Memorandum

To: Mayor and Councilmembers
From: Christa Johnson, Town Manager
Date: February 25, 2026
Subject: Overview of FORF's submittal package to the Ross Town Council

Technical Review of FORF Proposal Presented to the Town Council on January 8, 2026

Initial (Preliminary) Technical Review of FORF Concept

Life Safety Deficiencies (Egress, Separation, Fire Protection)

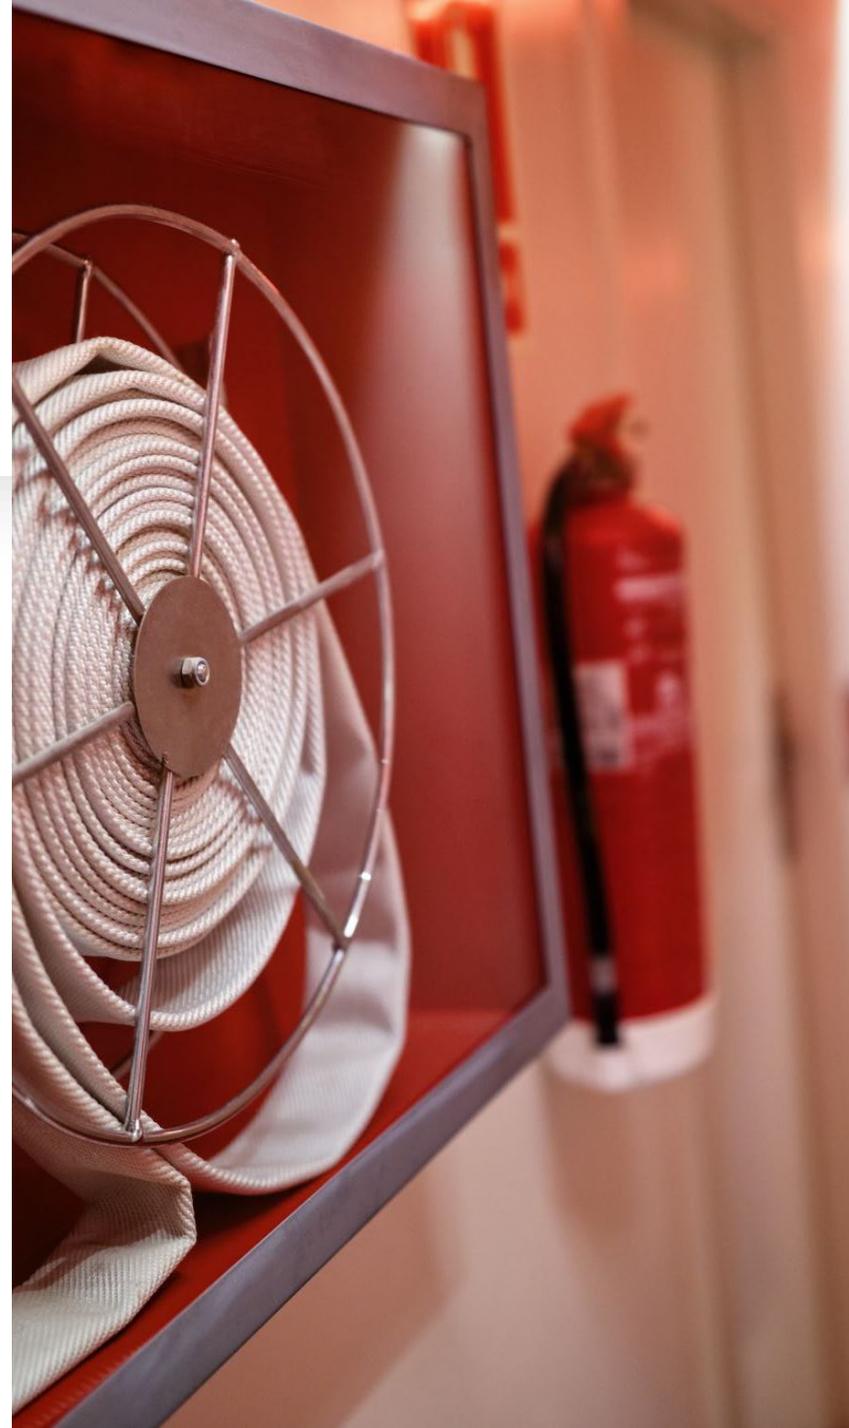
- **Life Safety Deficiencies (Egress, Separation, Fire Protection)**
- **Key findings:**
- Expansion of the second floor requires:
 - A second exit, which is not shown
 - A 1-hour fire separation
 - Fire protection of all supporting structural elements
- No legal exit from the apparatus bay to the exterior
- Unclear whether Alten's bid includes:
 - 1-hour separations
 - Fire sprinklers
 - Fire alarm system
 - Smoke detection in living areas
 - Generator automatic transfer switch
- No fire riser shown
